Report Title:	Brocket Task and Finish Group
Contains Confidential or Exempt Information?	NO - Part I
Member reporting:	Councillor Gerry Clark, Chair of Task and Finish Group
Meeting and Date:	Cabinet Prioritisation Sub Committee 17 May 2017
Responsible Officer(s):	
Wards affected:	Boyn Hill

THE BROCKET . BOYN HILL AVENUE . MAIDENHEAD
FEASIBILITY STUDY

Comment by Cllr Claire Stretton on the Feasibility Study conducted by CSK Architects to ascertain its suitability for use as a residential scheme or mixed-use scheme with the Registrar's Office

RESPONSE TO REPORT PREPARED BY COUNCILLOR CLAIRE STRETTON – VERSION 3

1592 / SK01

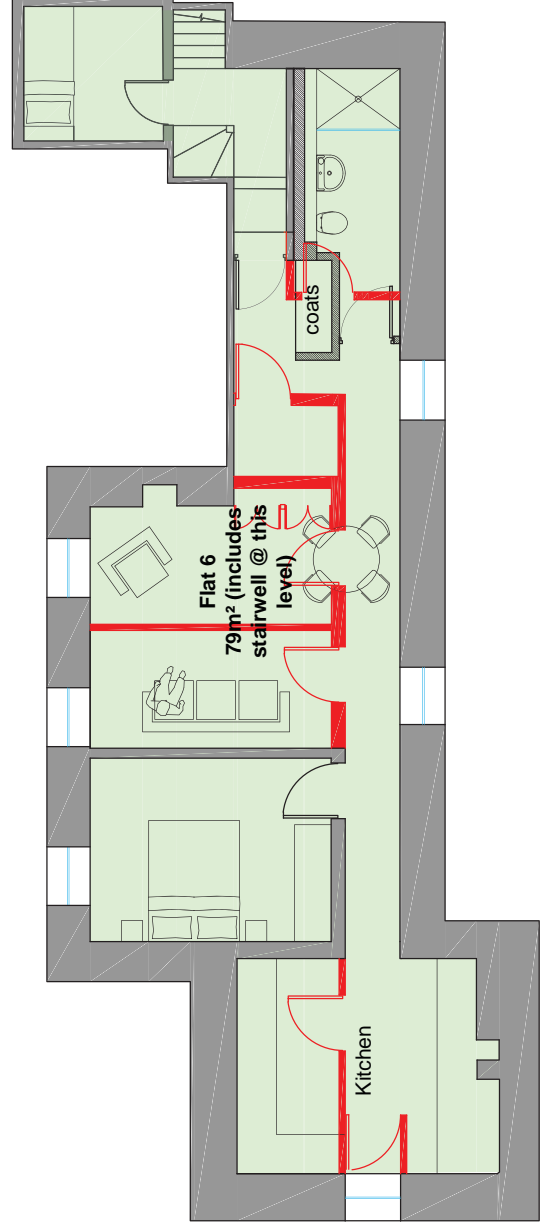
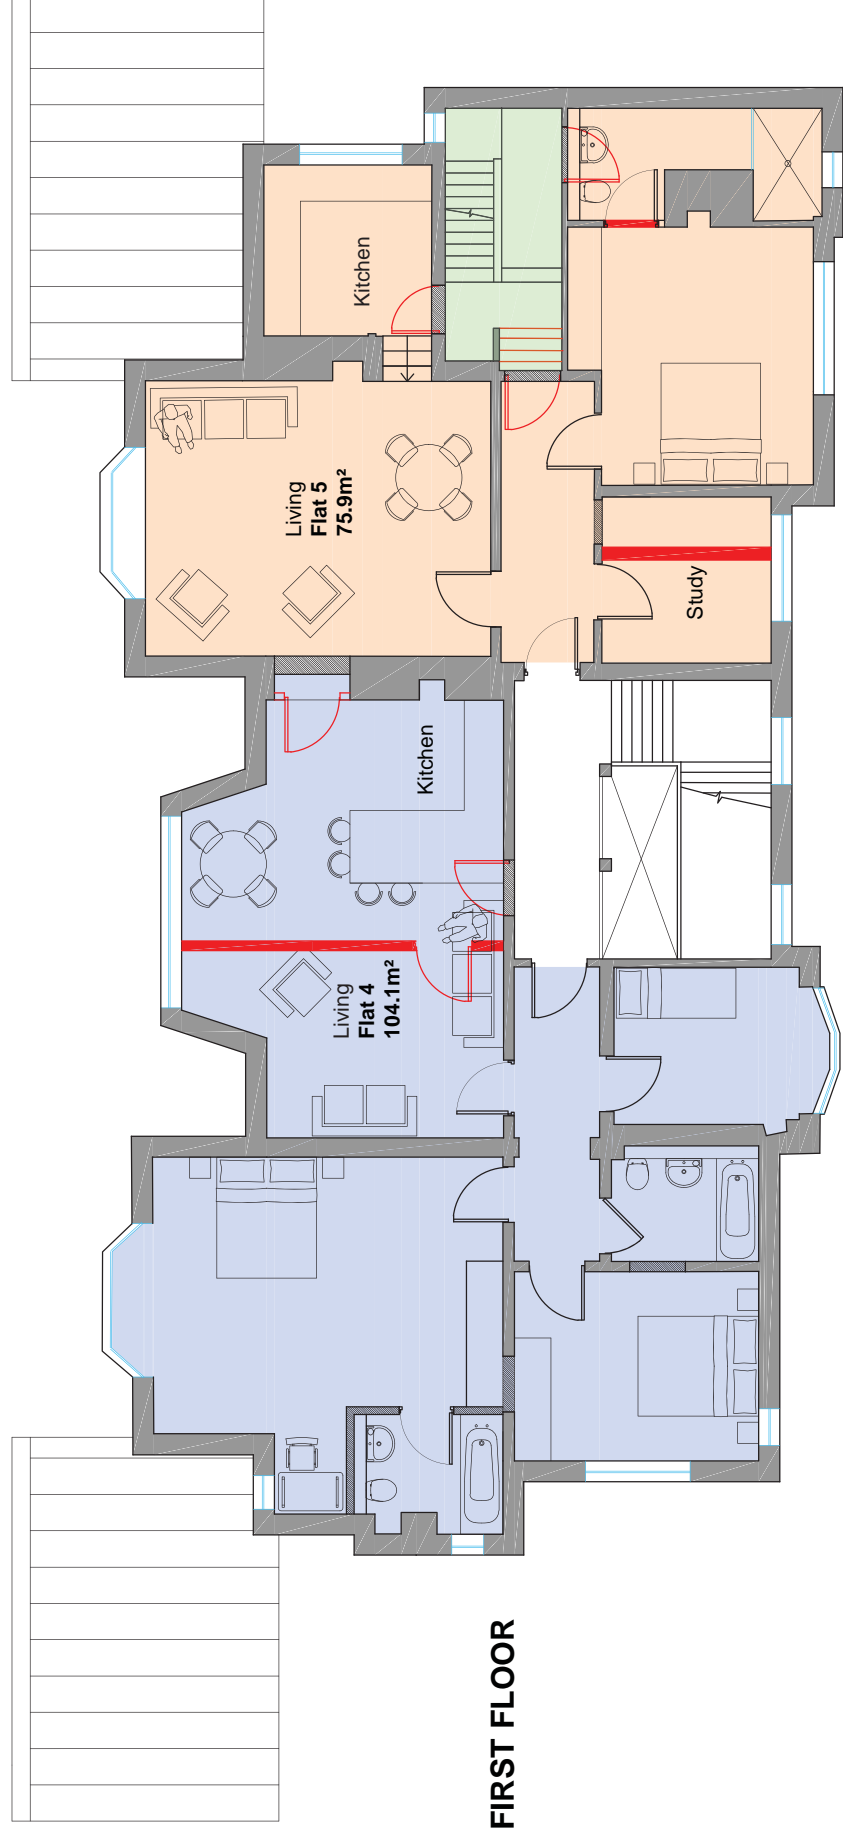
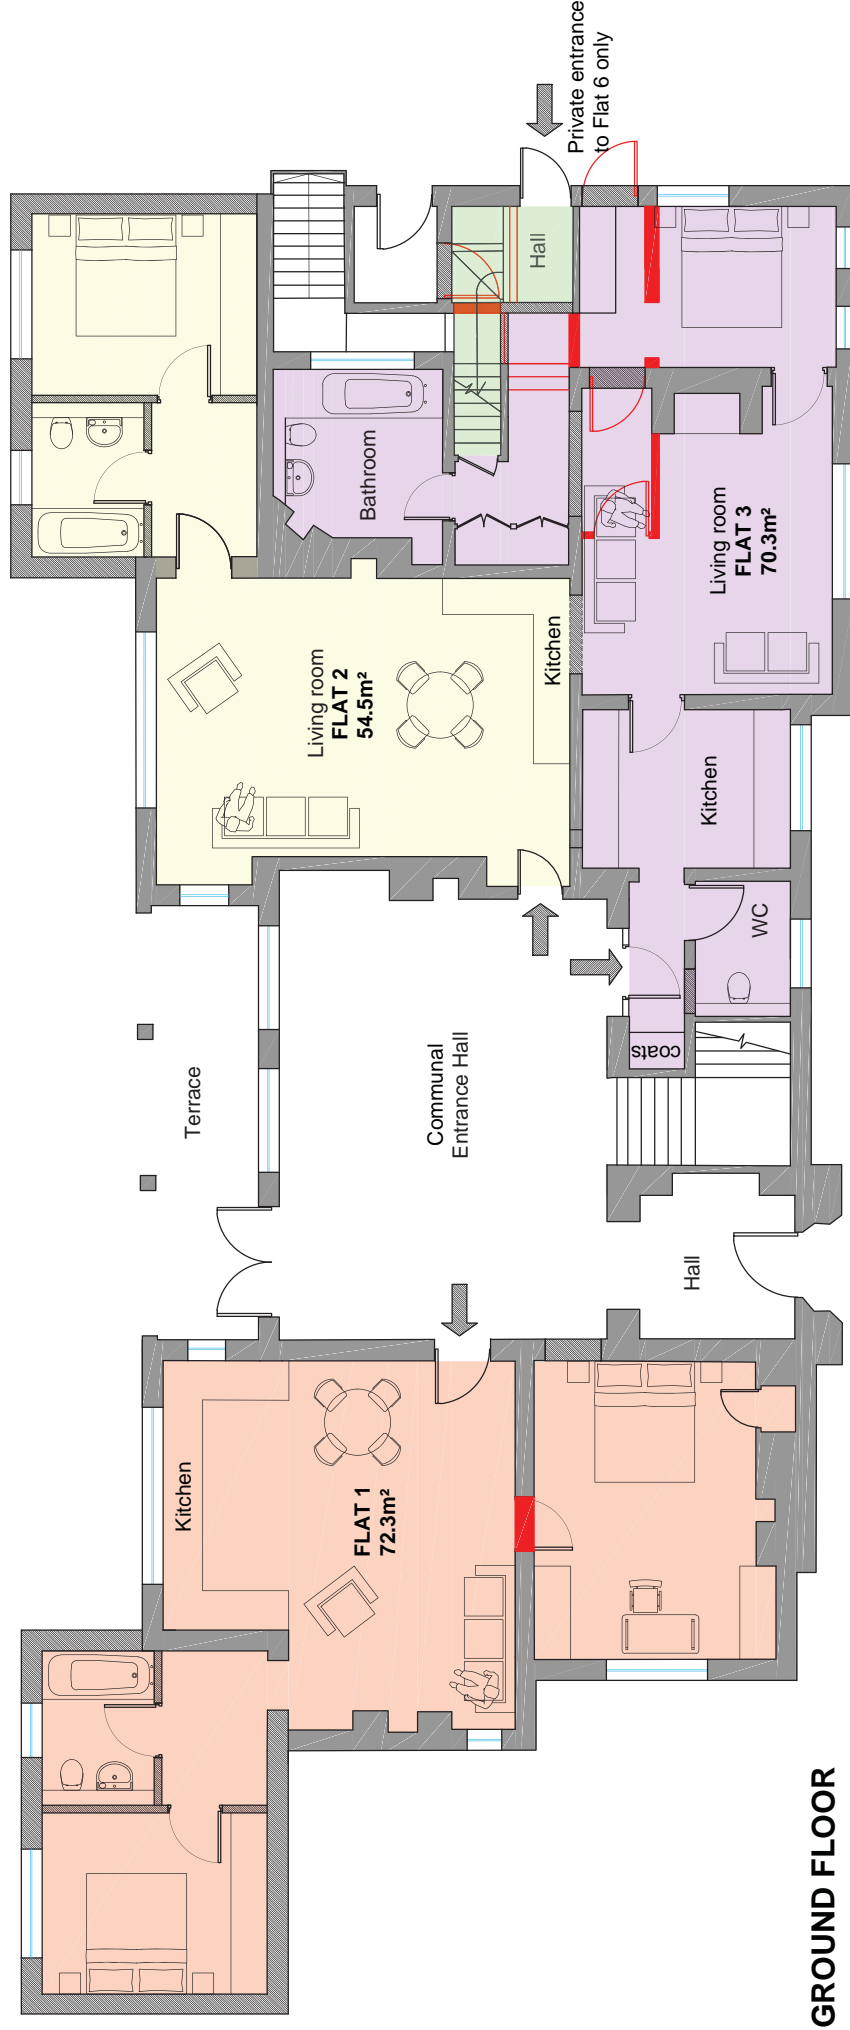
Advantages: This layout makes maximum use of the existing main entrance and panelled reception at ground floor. It allows 5 out of the 6 units to be accessed off this central space which could also be the main access for residents into the rear garden. It allows both first floor flats to use the main staircase for access. This approach is likely to be welcomed by the listed building officer as it retains the use of the principal entrance and principal stair.

The front courtyard can re-landscaped to provide 12 car parking spaces, 2 per flat.

The integrity of the existing rooms are retained with minimal demolition.

The size / mix of units are suitable for key workers.

Disadvantages: There will need to be robust acoustic and fire separation between each flat – at first floor where there are listed features and this will be less straight forward than on the upper floor.

1592 / SK02

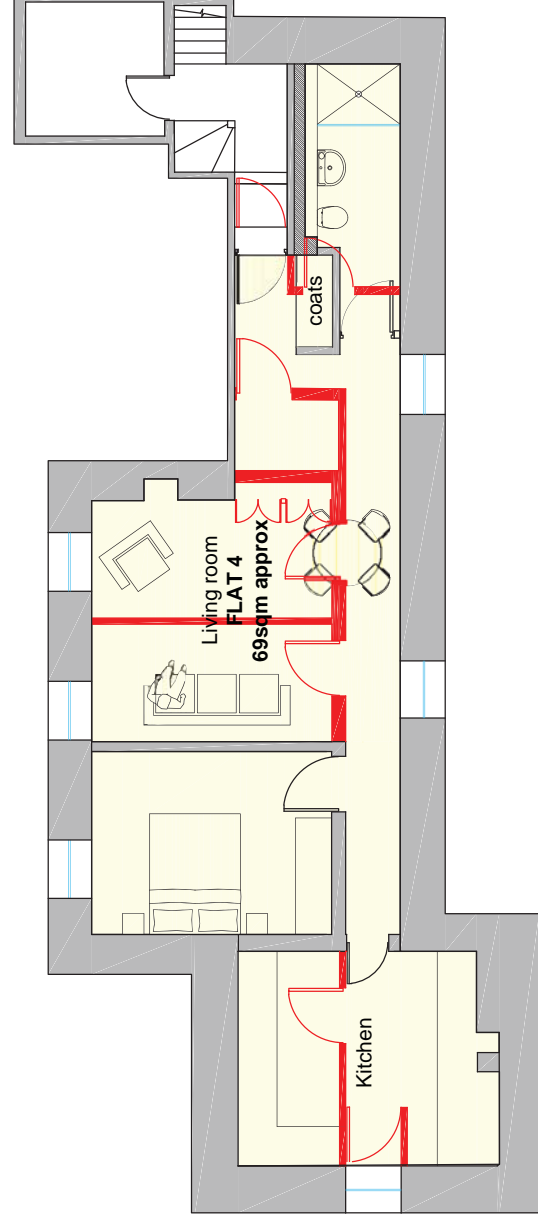
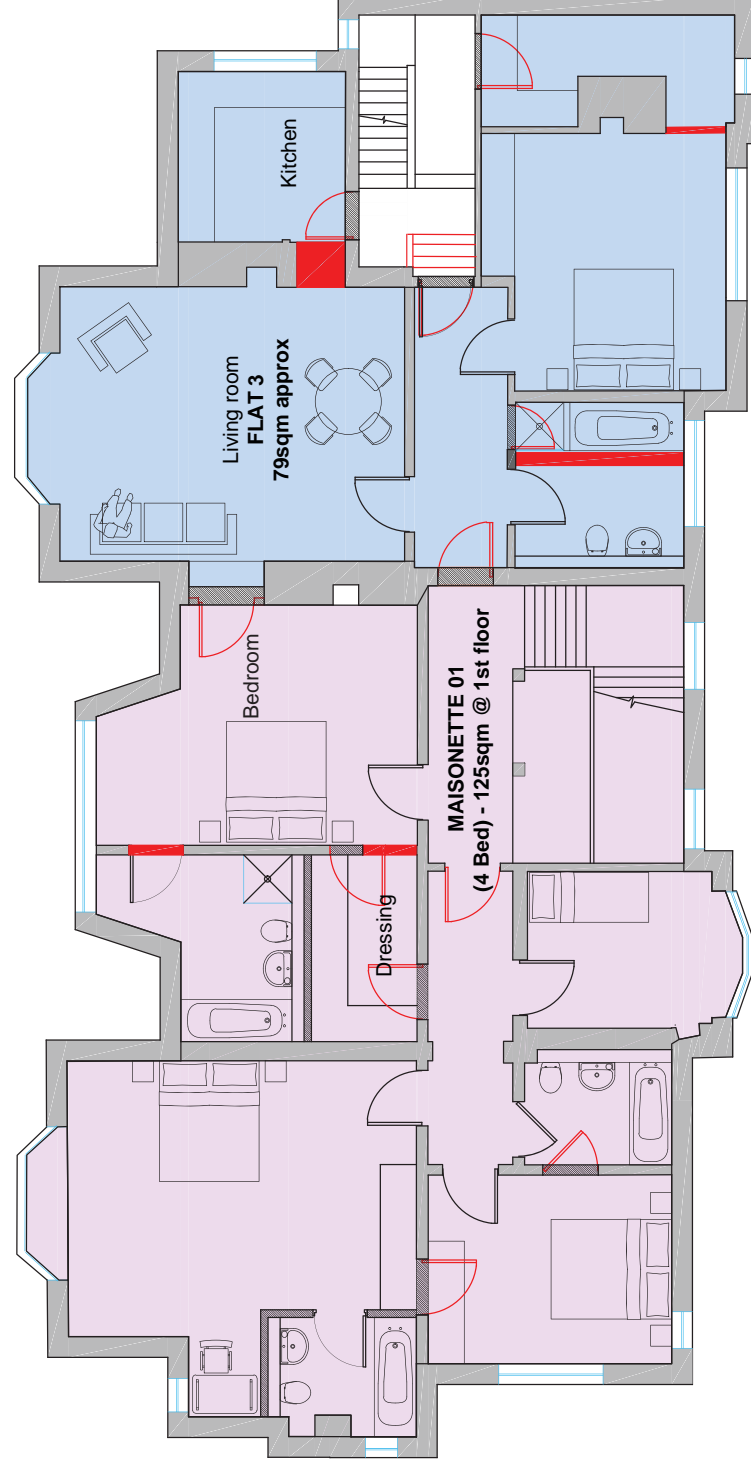
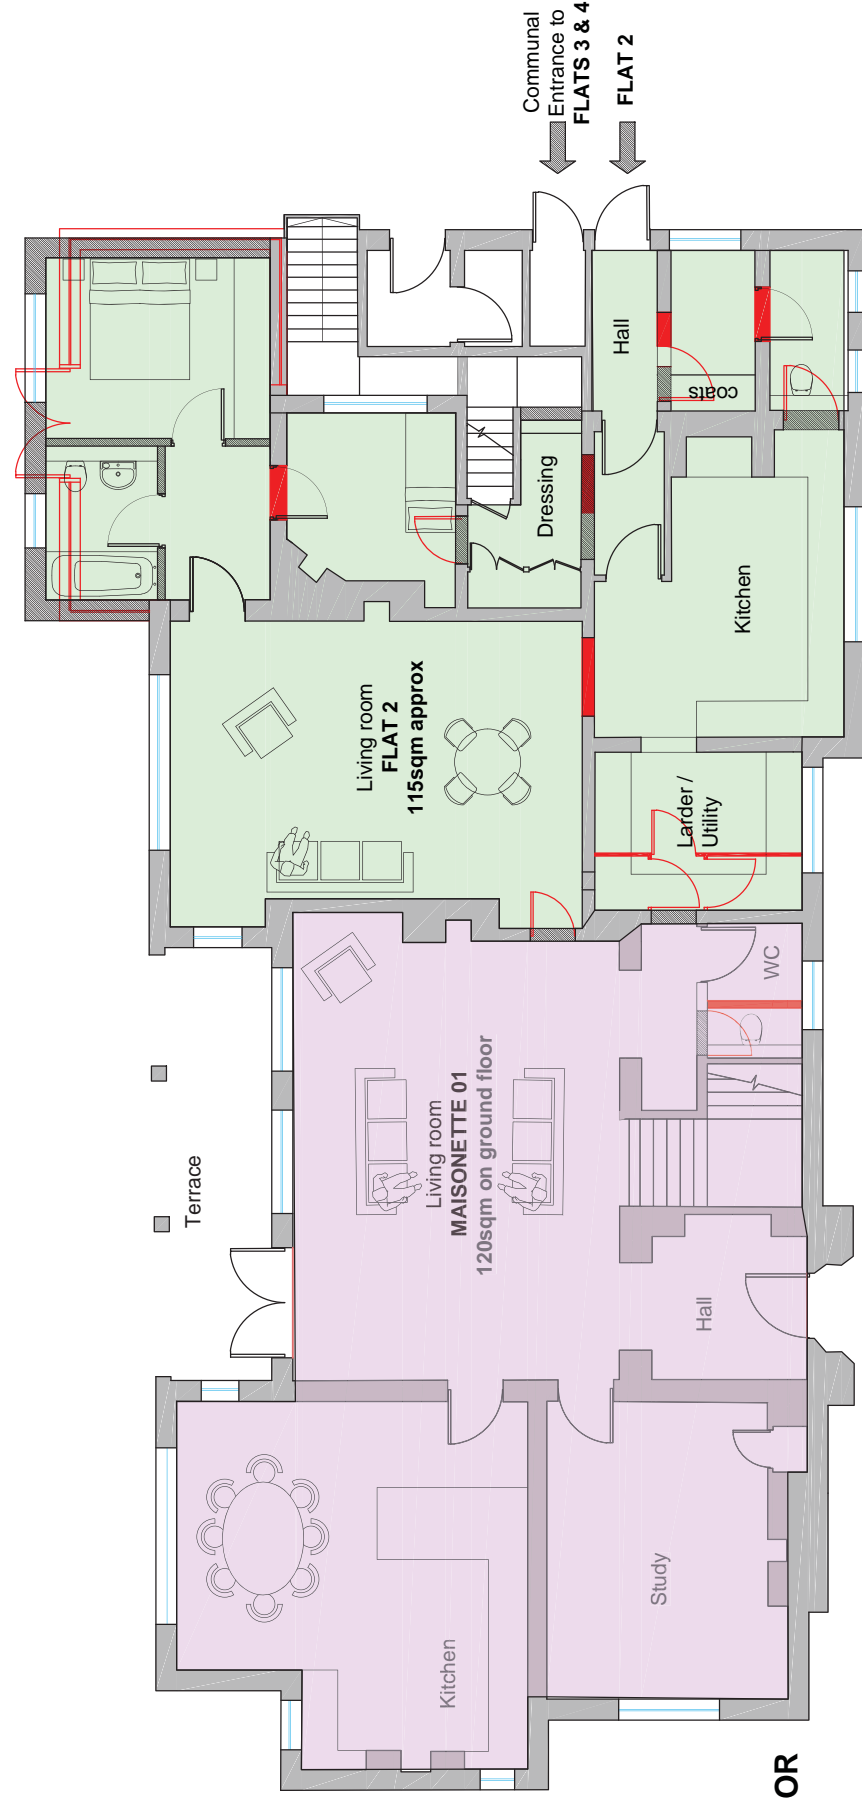
Advantages: The principal reception room becomes useable floor space as opposed to communal circulation space.

The acoustic / fire separation is slightly easier as it is not needed between ground and first floor where there is a maisonette.

Disadvantages: The maisonette is very large and not best suited for keyworker housing. Only the single unit has the benefit of the grand panelled reception room and staircase. This large unit is still blighted in part by a flat at second floor sitting above it.

The first floor flat is now accessed around the side, via very much a secondary stair.

1592 / SK03

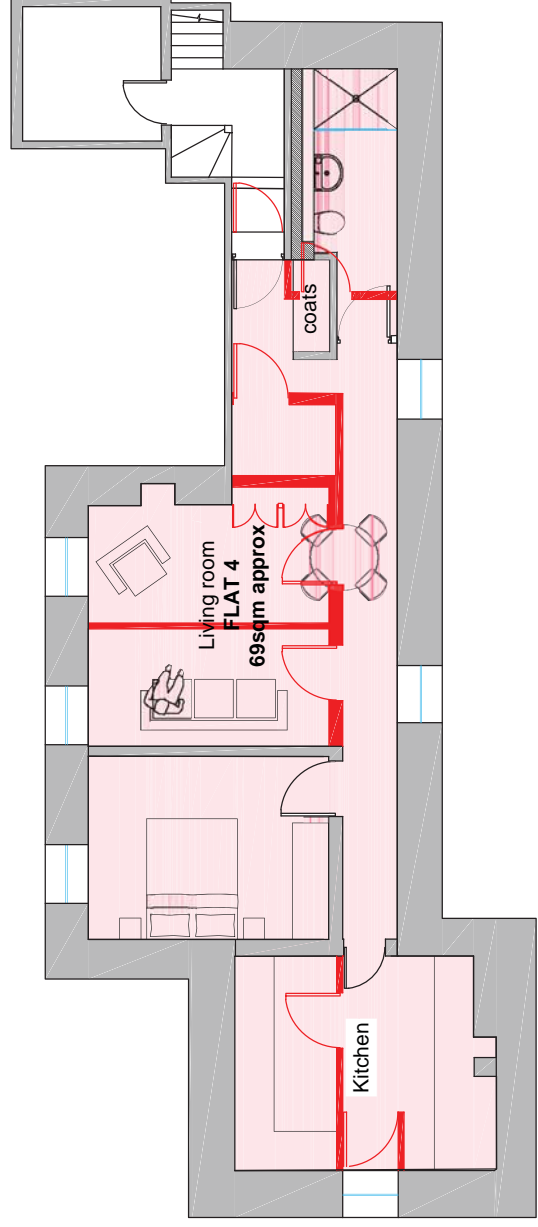
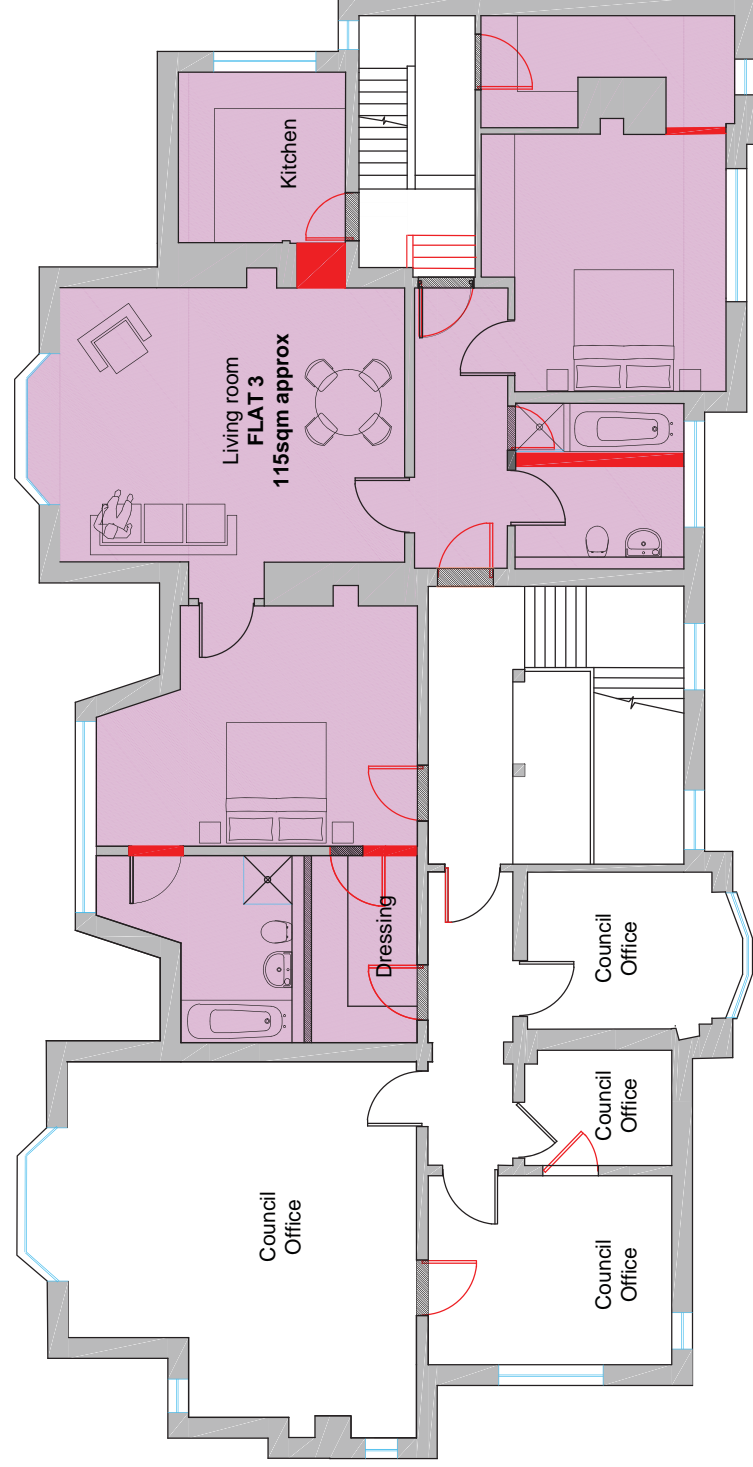
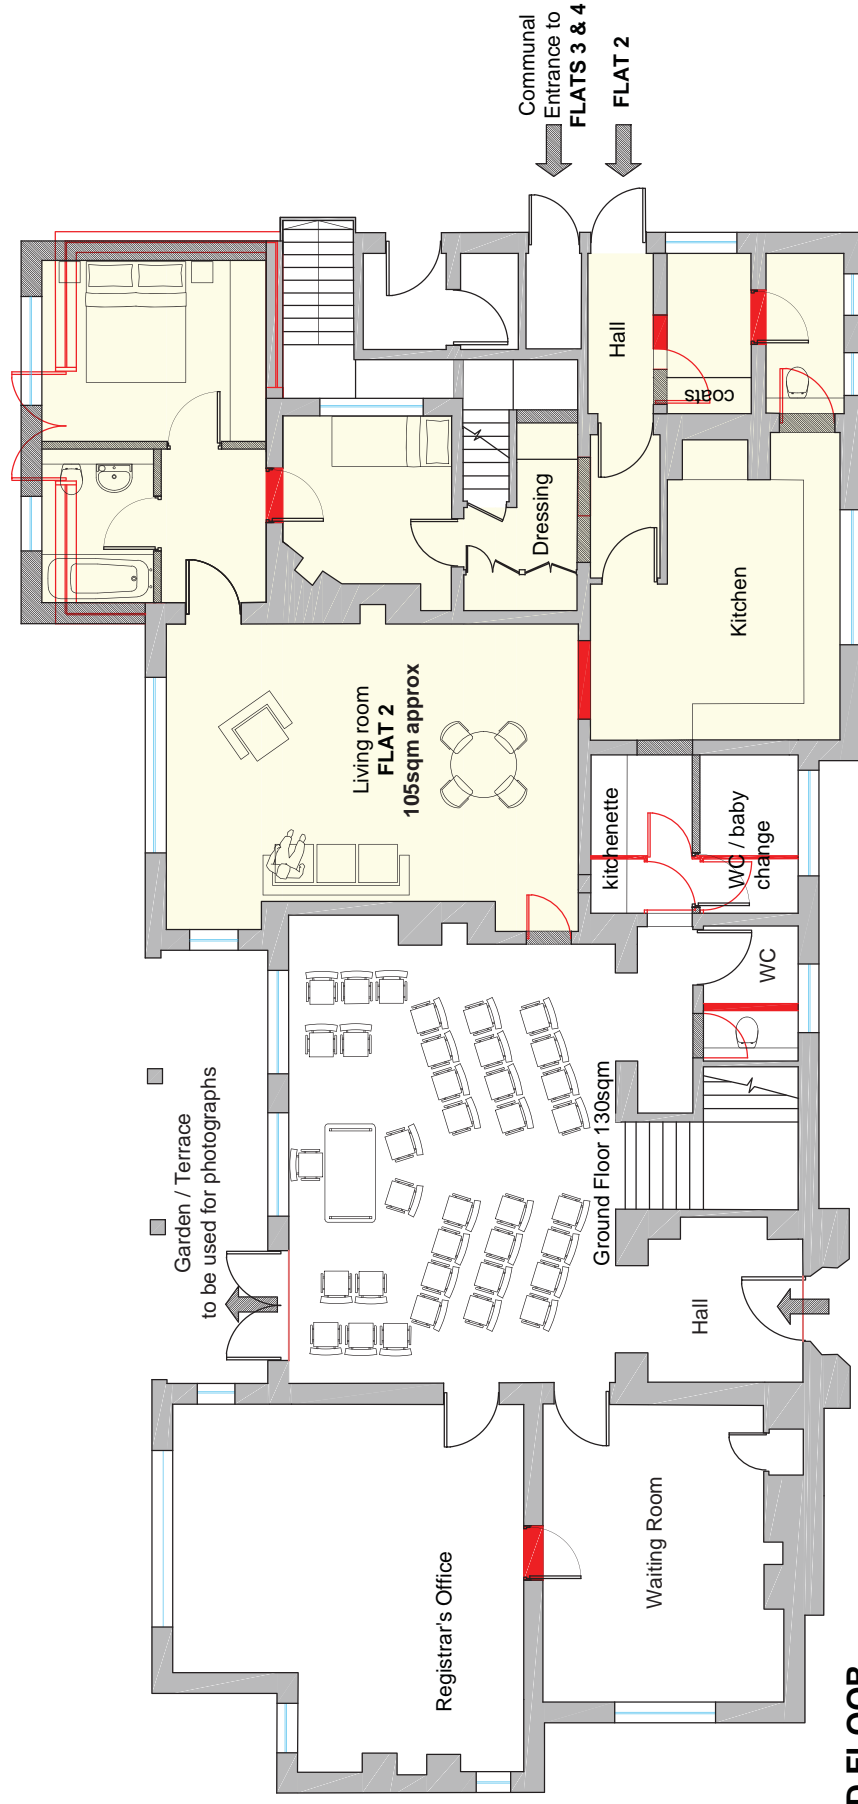
Advantages: This layout makes use of the principal reception room as a public space. The panelled room is a handsome room and taken at face value it would appear to suit the function of a registry office.

Disadvantages: The main room isn't that big – it can't accommodate the 48 visitors usually needed for a large marriage. Because it is a listed building it is not a simple case of knocking two rooms together to create a larger room. The integrity of each of the main rooms with their associated cornice/panelling/skirting etc must be respected.

There is limited options to increase the parking on the site, beyond 12 spaces. Depending on the status of the Copper Beech on site, even this number of spaces may not be possible. For a large marriage with say 30 guests, parking will not be sufficient.

The existing principal stair must be retained and it must lead somewhere. This necessitates commercial space at first floor.

There is both a vertical and horizontal overlap between commercial space and residential accommodation with complicates both the acoustic and the fire separation.

It is difficult to see how marriages could be run back to back. Access to the main waiting area involves entering the main room where the service would be in progress.
